# Access Compliance Report

## Public Rights-of-Way

### (Curb Ramps)

Intersection ID: 18795	Main Street: LAMONT_DR	Cross Street: SENECA_PL	Location: NW
ADA ID: 01AD985B9B3C	Ramp Type: PerpDiag	Initial Pass/Fail: Fail	Overall Compliance: No
Severity Score: 33.75			
Codes/Mitigation Info/Possible Solution		Field Measurements/Component Compliance

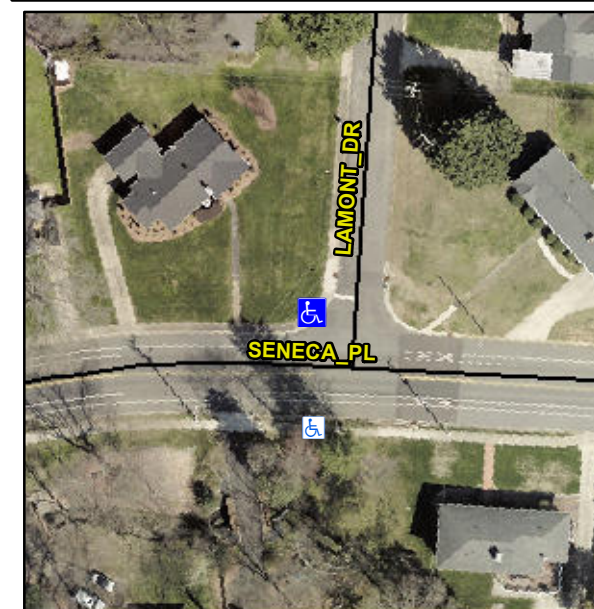
**Not Found, R304.5.1, R304.2.2, R304.5.3**

Compliance	Description	Data	Compliance	Description	Data
N/A	Ramp Length (in)	50.0	No	Ramp Slope (%)	8.8
No	Ramp Width (in)	44.0	No	Ramp XSlope (%)	5.1
N/A	Flare Type LT	N/A	N/A	Flare Type RT	N/A
N/A	Flare Slope LT (%)	N/A	N/A	Flare Slope RT (%)	N/A
N/A	Flare Traversable LT?	N/A	N/A	Flare Traversable RT?	N/A
N/A	Landing Length (in)	N/A	N/A	DWS Provided?	N/A
N/A	Landing Width (in)	N/A	N/A	DWS Contrast?	N/A
N/A	Landing Slope (%)	N/A	N/A	DWS Length (in)	N/A
N/A	Landing X Slope (%)	N/A	N/A	DWS Full Width?	N/A
N/A	Landing Curb? (Y/N)	N/A	N/A	DWS Offset (in)	N/A
N/A	Shared Landing?	N/A			
N/A	Gutter Ponding?	N/A	N/A	Gutter Slope (%)	N/A
N/A	Gutter Lip Ht (in)	N/A	N/A	Gutter X Slope (%)	N/A
N/A	Painted X Walk1?	No	N/A	Painted X Walk2?	No
	X Walk 1 Direction	To S		X Walk 2 Direction	To E
N/A	X Walk 1 Width (in)	N/A	N/A	X Walk 2 Width (in)	N/A
	X Walk 1 Slope (%)	1.5		X Walk 2 Slope (%)	2.8
	X Walk 1 X Slope (%)	2.7		X Walk 2 X Slope (%)	2.9

**Remove & Replace Curb Ramp With Two New Directional Ramps or Equivalent.**
